## Philco Radio & Television Corp.

**Model:** 89

MODELS 19, 38, 89

## Correcting Intermittent Operation

Figure 4—Schematic Wiring Diagram

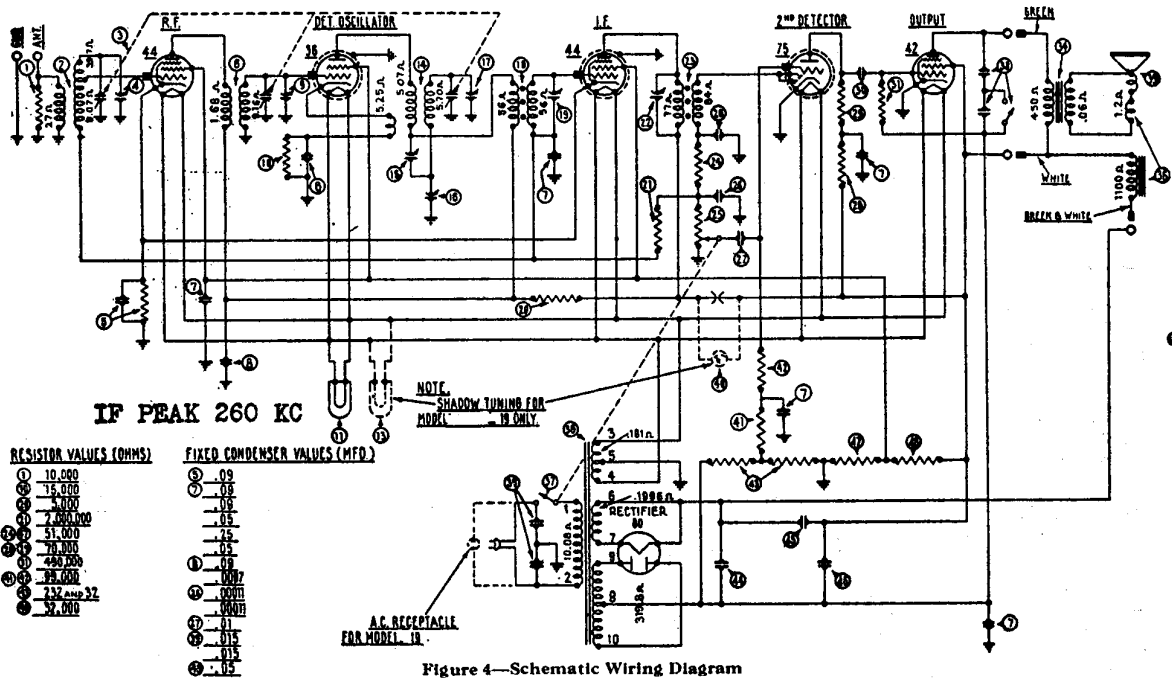
In run number 5; the antenna coil ⓐ part number 06619 was changed to new coil part number 32-1062. The interstage coil ⓑ part number 06662 was changed to new coil part number 32-1063. The volume control and A. C. switch ⓓ part number 33-5004 was changed to new Volume Control (only) part number 33-5007. A combined "On-Off" and frequency change switch was added, part number 42-1002. The above changes permits the police and airplane broadcast reception.

In run number 2, Model 19-121; run number 3, Model 19-122; a (2900 ohms) resistor, part number 5309 was added. This resistor was connected between ⓐ condenser, lug No. 3 to lug No. 5 on the condenser mounted between ⓑ antenna transformer and the R. F. socket.

The following changes were made in 19-122 to make 19-123 under run No. 1:

The sub base part number 8136 was changed to new sub base part number 29-1051. The tuning condenser assembly part number 06702 was changed to new condenser assembly part number 31-1004. The dial scale 8111 was changed to new dial scale 7882. The A. C. Socket part number 5962 was removed. The bottom shield part number 8057 was removed. The two side brackets part numbers 8133 and 8134 were removed. Four new mounting feet part number 4222 were added. The two electrolytic condensers part number 8095 were changed to part numbers 8165 and 8166.

Below run number 4 on 89-121; run number 1 on 19-121; run number 2 on 19-122, the wiring on the compensating condenser ⓐ was reversed and the fibre nut, part number 7505 was changed to part number 3151 (brass nut); part number W-775 hole cover was added.

Notes for 25 cycle Model 89-A.

Use ⓐ power transformer part number 8047. Change ⓑ electrolytic condenser (6 mfd.) part number 8165 to new condenser (8 mfd.) part number 7558. Change ⓓ electrolytic condenser (6 mfd.) part number 8166 to new condenser (8 mfd.) part number 7558.
